**RE: Amendment Request for License Number 20-23904-01E and SSD Certification No. NR-0399-D-101E**

We would like to request an amendment to our NRC Exempt Distribution license no. 20-23904-01E, and our NRC SSD Certificate no. NR-0399-D-101E, to change our mailing address and remove a distribution address, as we no longer lease one of the addresses currently listed on the documents.

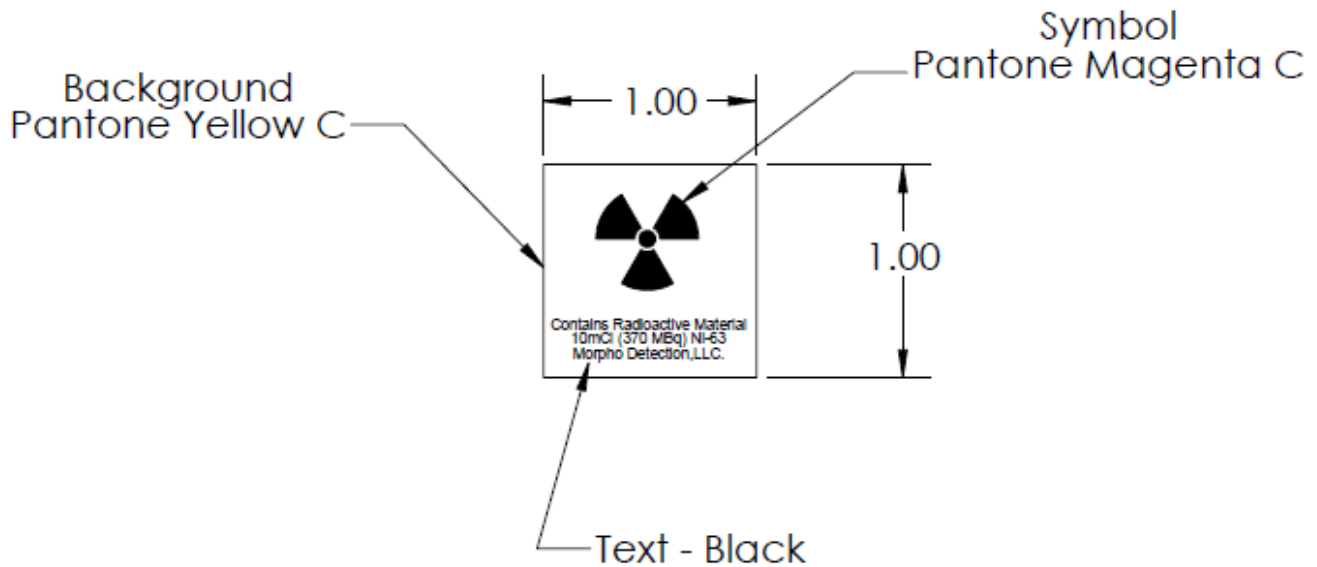
plans to distribute products from this location again as it is no longer leased by Morpho Detection. If this necessitates the removal of the Wilmington address from the certificate, please remove it. If it should not be removed as the address was formerly used to distribute products, no change is necessary.
Change “formerly” label.	Please change the “(formerly GE Homeland Protection, Inc.)” label under the “Distributor/Manufacturer” section to say “(formerly GE Homeland Protection, Inc. and Morpho Detection, Inc.)”
Modify trefoil label on detector housings.	Please change the trefoil label on the detector housings, depicted in attachment 9, to the image below showing the current company name. Depicted dimensions are in inches.
